<b>Product / Process Change Notification (PCN)</b>	
<input type="checkbox"/> Major Change <input checked="" type="checkbox"/> Minor Change	
<b>PCN Number:</b> PCN_UtRJ45LAN_20240813  <b>Affected Series:</b> WE-RJ45LAN  <b>Affected Order Codes:</b> 74990100011A, 7499111447, 7499211125, 7499211126, 7499111449, 7499210001A, 7499010003A, 74990111217, S18100087, S19100038, S19100110  <b>PCN Date:</b> 2024-05-13 (YYYY-MM-DD) <b>Effective Date:</b> 2024-08-13 (YYYY-MM-DD)	<b>Change Category:</b> <input type="checkbox"/> Equipment/Location <input type="checkbox"/> General Data <input type="checkbox"/> Material <input checked="" type="checkbox"/> Process <input type="checkbox"/> Product Design <input type="checkbox"/> Shipping/Packaging <input type="checkbox"/> Supplier <input type="checkbox"/> Software
<b>Contact:</b> Product Management <b>Phone:</b> +49 (0) 7942 - 945 5001 <b>Fax:</b> +49 (0) 7942 - 945 5179 <b>E-Mail:</b> pcn.eisos@we-online.com	<b>Datasheet Change:</b> <input type="checkbox"/> Yes <input checked="" type="checkbox"/> No  <b>Attachment:</b> <input type="checkbox"/> Yes <input checked="" type="checkbox"/> No

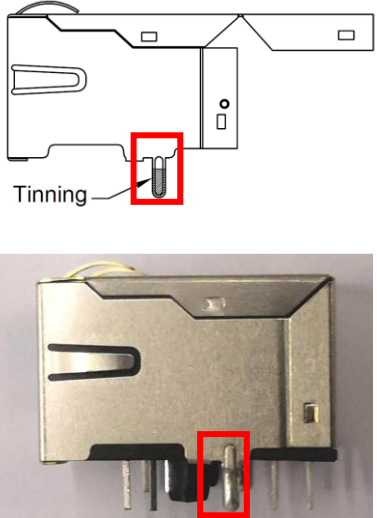
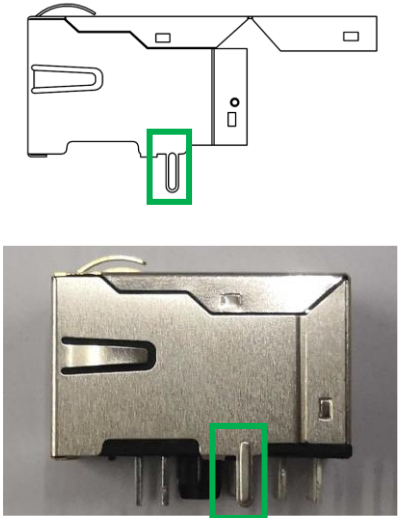
Before Change	After Change
<p>Before the change we used pre-tinned shielding pins.</p> 	<p>After the change there will be totally plated shielding pins without additional tin.</p>
